PERMIT

P #30477
A Repair

SEWAGE DISPOSAL SYSTEM

APPLICATION

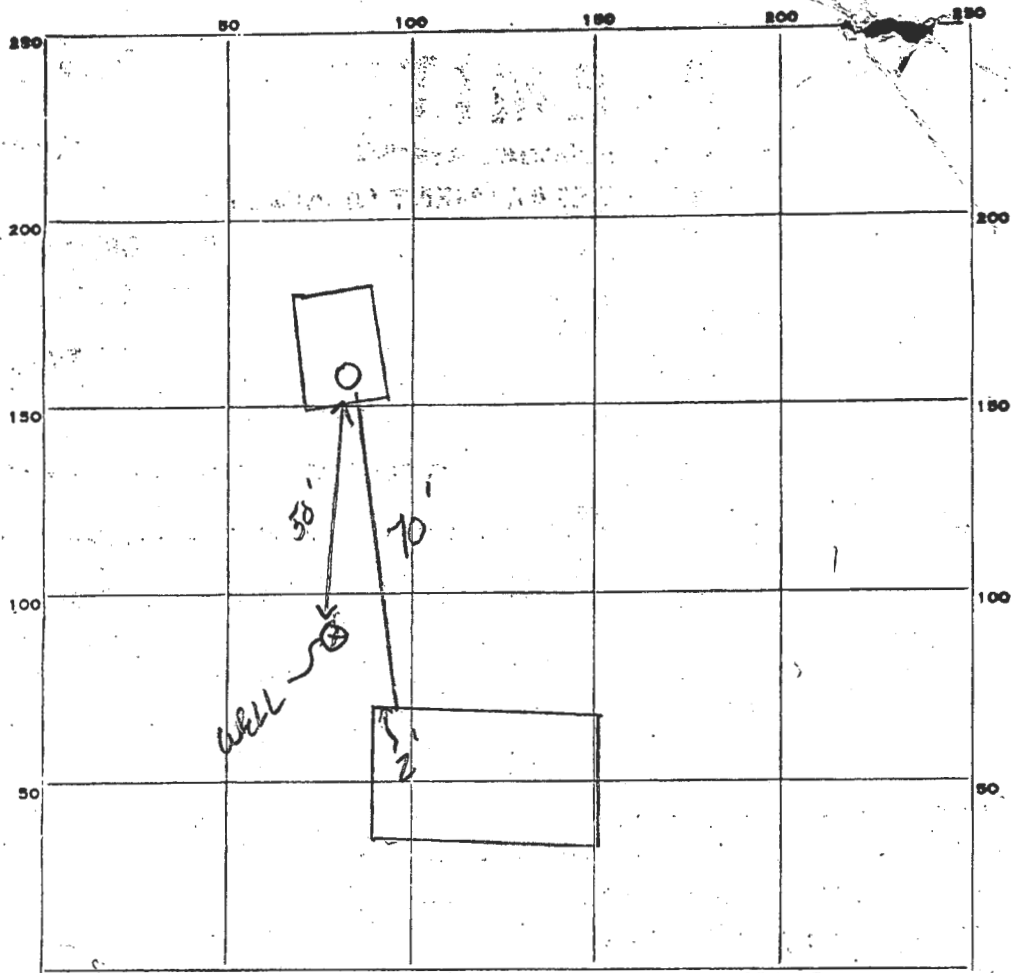
REPAIR - Install 1000 gallon sealed tank for kitchen wastewater disposal. PLACE TANK

AT LEAST 50 FT FROM WELL PREFERABLY 75 FT,
AT LEAST 10 FT FROM THE LOT LINE

HAVE ALARM SYSTEM ON TANK & MANHOLE

REMARKS 7/25/80 2:00PM - NOTHING DONE NO ONE AT SITE RH
 7/25/80 - 3:30PM TALKED TO MRS SMITH RE 7-30-80 OK TO COVER
 all work, NEED AN OVER FLOW ALARM BEFORE FINAL APPROVAL
 JS+SR 9/8/80 ^{SAW} ELECTRIC WIRES LEADING FROM SEPTIC TANK TO HOUSE; SAW
 LIGHT INDICATOR INSIDE BACK DOOR ON RIGHT WALL.

SOIL PROFILE

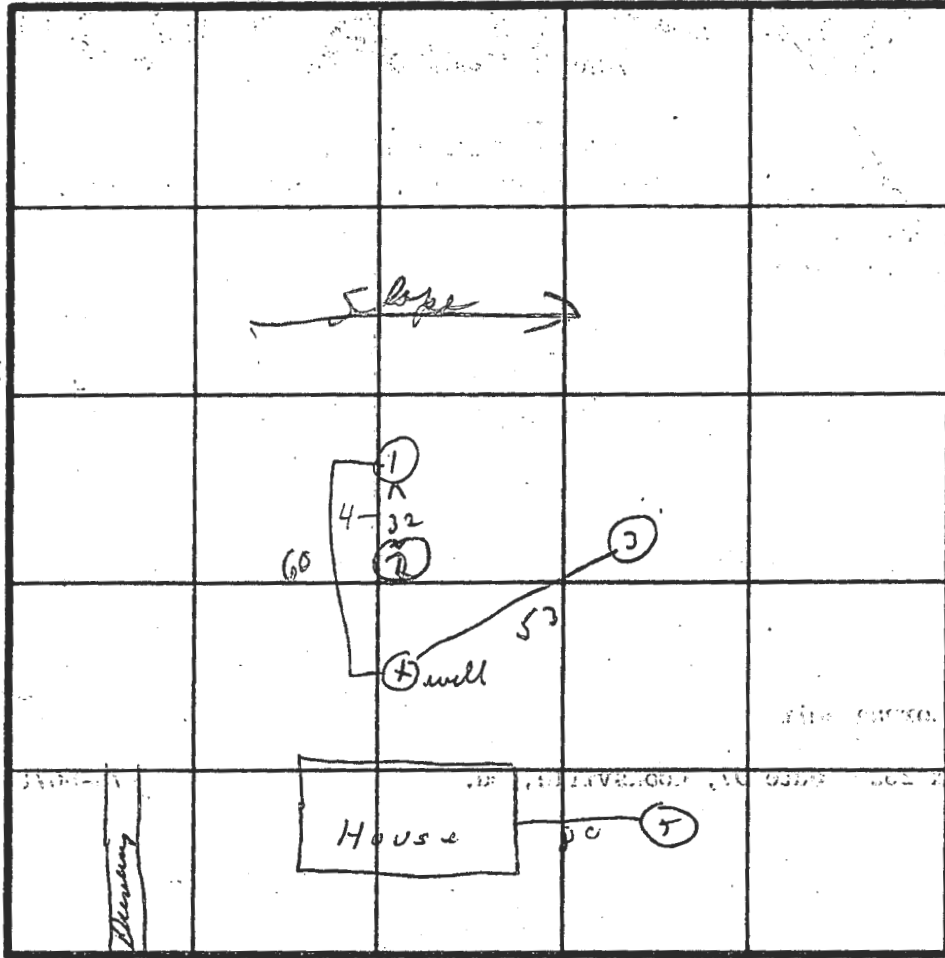
REJECTED BY Don [initials] FOR any system DATE 1-10-80

DATE	TEST NO.	DEPTH	PRE-WET		TEST AT DROP		TIME
			START	STOP	START	STOP	
1/10/80	1	12 ft	all clay	-	water at 9 ft		
	2	10 ft	mostly clay		water at 10 ft		water breaking in at 7 ft.
	3	9 ft	water				
	2A	4 ft	9 22	9 37	9 37	10 15	36 min of air
	1A	4 ft	9 40	10 00	10 00		about 1/2" drop out 10 25
	4	1 1/2	9 46	10 15	1" pore starts		
	5	4 ft	water		breaking in at 6 ft
